SUBJECT: Forwards Rev 1 to WCAP-10230, "Evaluation of Acceptability of Reactor Vessel Head Life Rig, ... to Requirements of NUREG-0612..." & requests relief from requirements of NUREG-0612 Table 3.1-1 re load block.

January 29, 1986
AEP:NRC:0514N

Donald C. Cook Nuclear Plant Nos. 1 and 2
Docket Nos. 50-315 and 50-316
License Nos. DPR-58 and DPR-74
NUREG-0612, "CONTROL OF HEAVY LOADS"
ADDITIONAL INFORMATION

PLANT ARRANGEMENT
MEZZANINE FLOOR EL. 609'-0"
UNITS 1 & 2

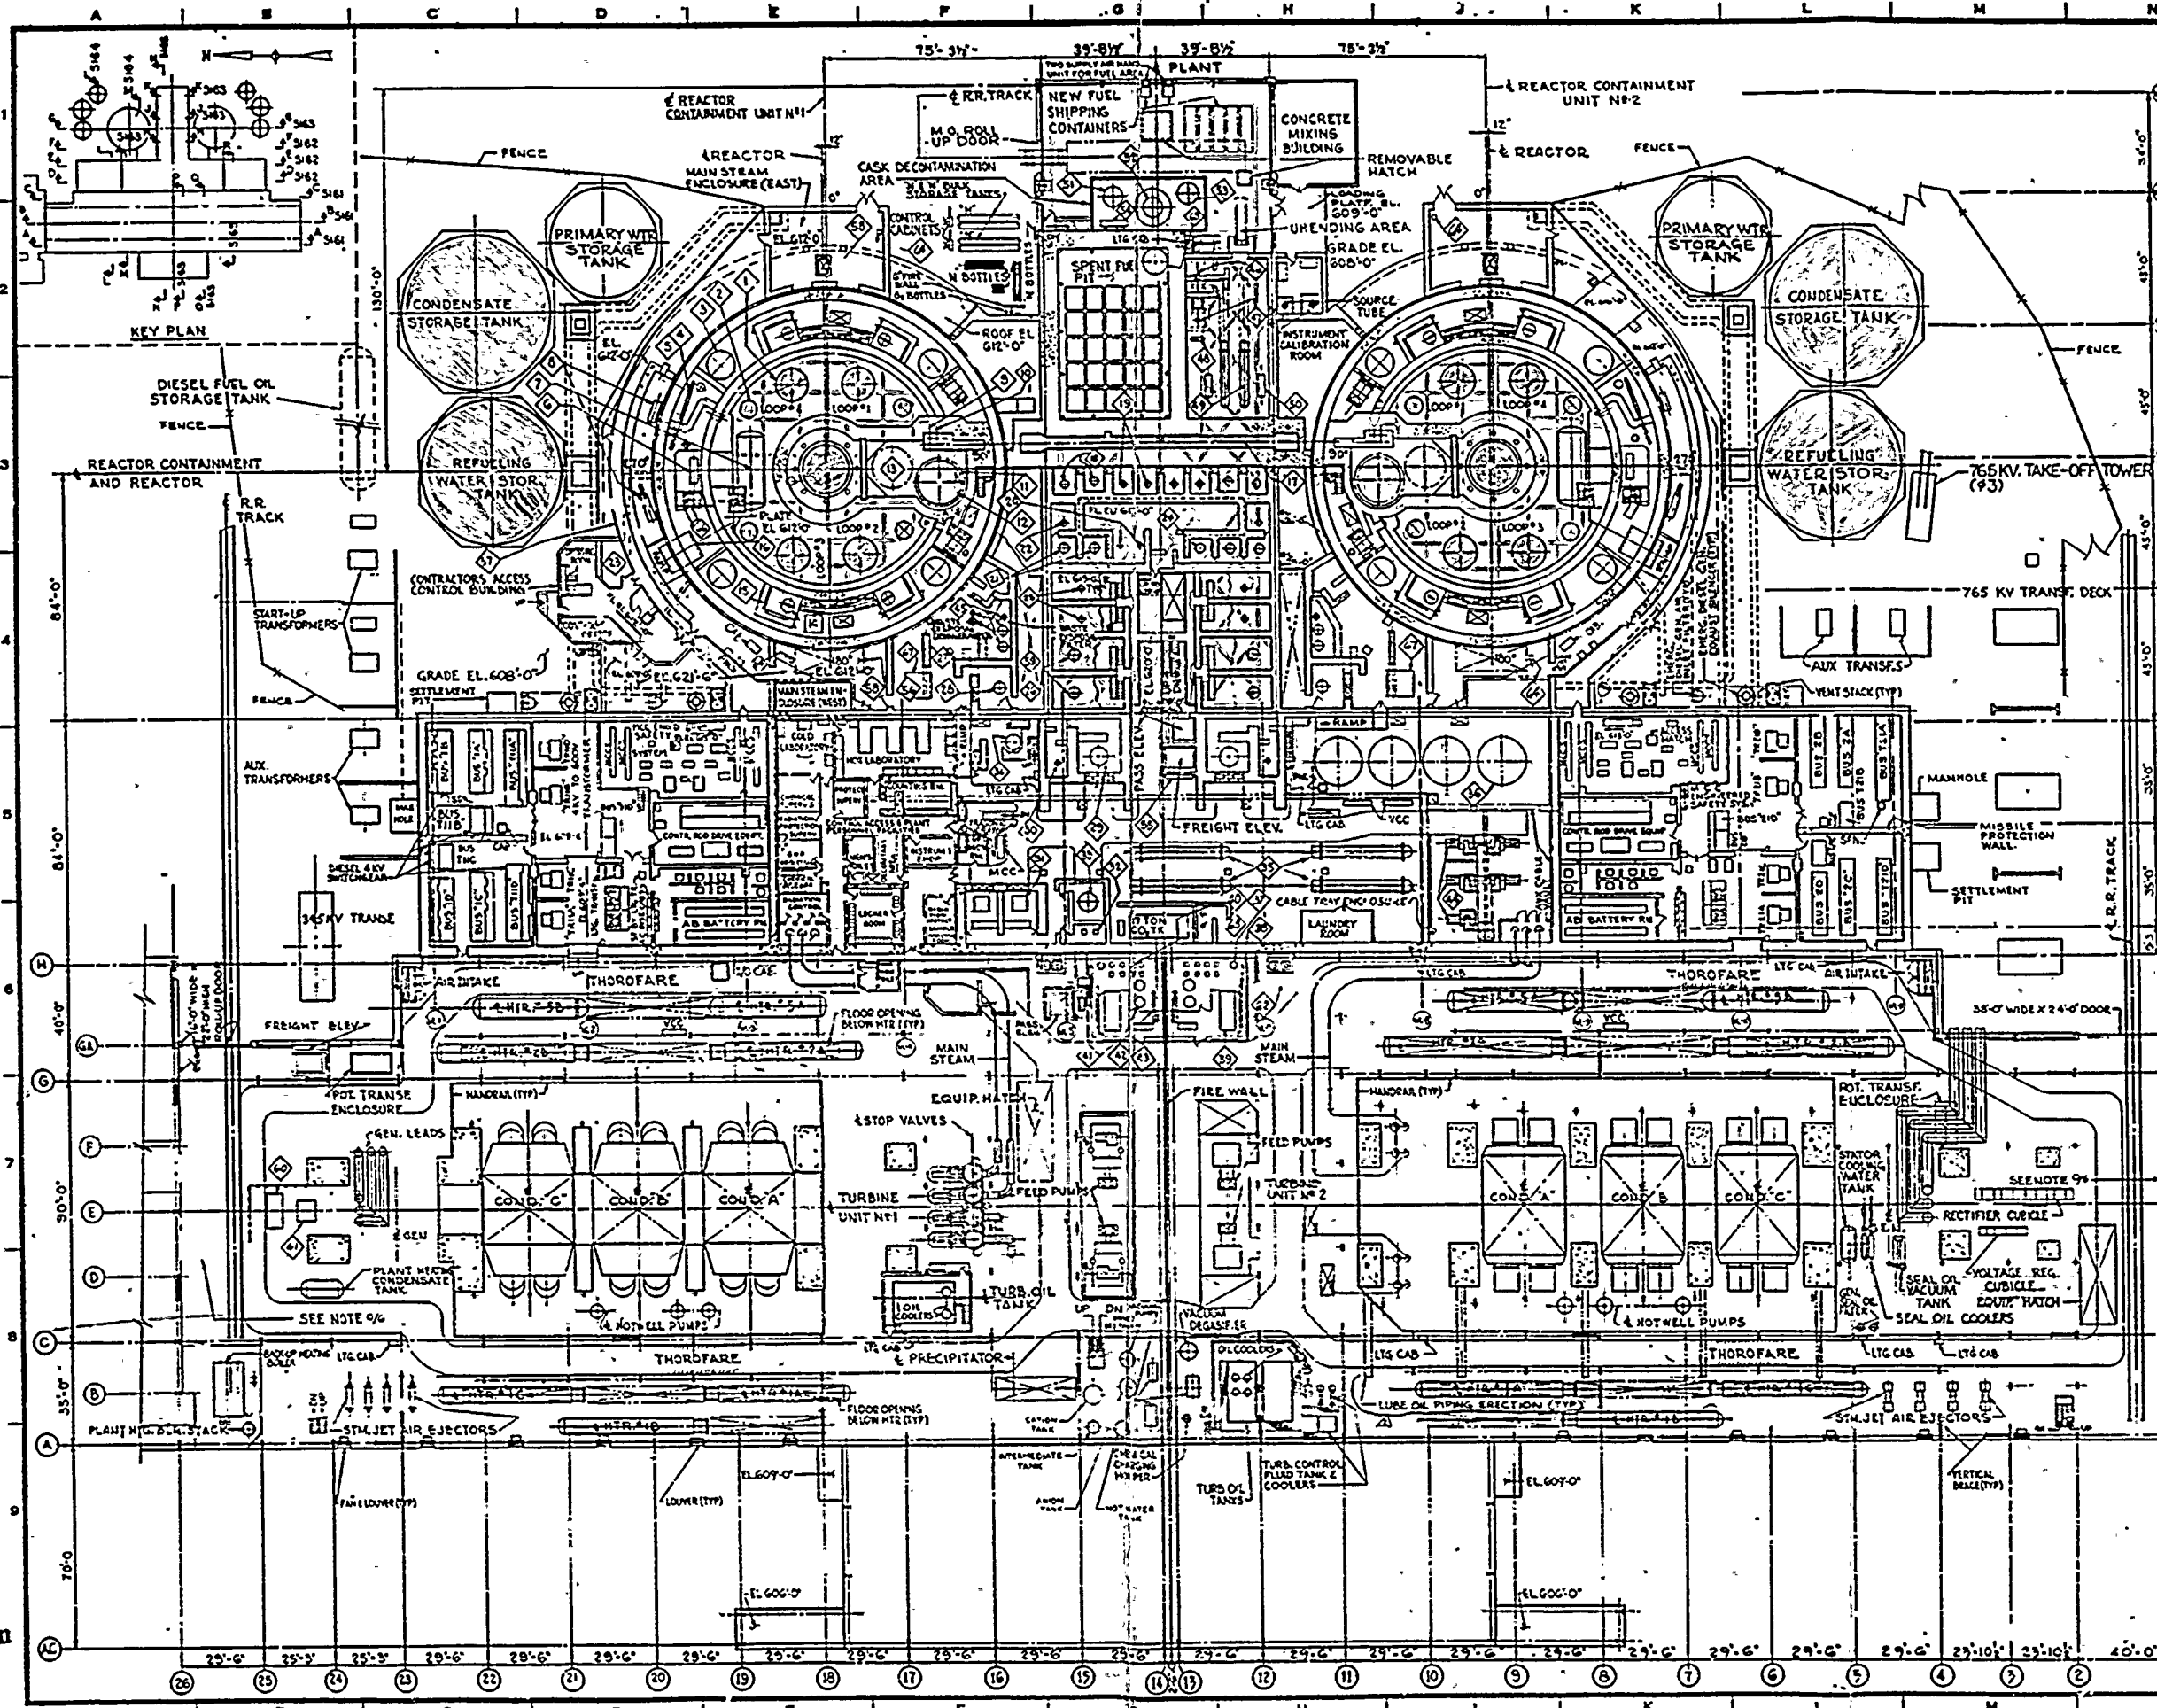
Currently we are performing a review of all our Phase II submittals to identify the action items, and in that process we have identified a discrepancy. In our submittal AEP:NRC:0514A, dated August 27, 1982, we committed to maintain a 15.0-foot horizontal separation from the pool, as per NUREG-0612 guidelines for movement of heavy loads near the spent fuel pool using the Auxiliary Building Crane. This was a discrepancy in our submittal, which we would like to correct. Based on our Phase I commitment of maximum horizontal separation, the maximum separation we can maintain is 9'-10½" on the south side and 5'-7" on the west side. The drawing showing the load path was submitted to your office as an attachment to letter AEP:NRC:0514C. It is being resubmitted for clarification.
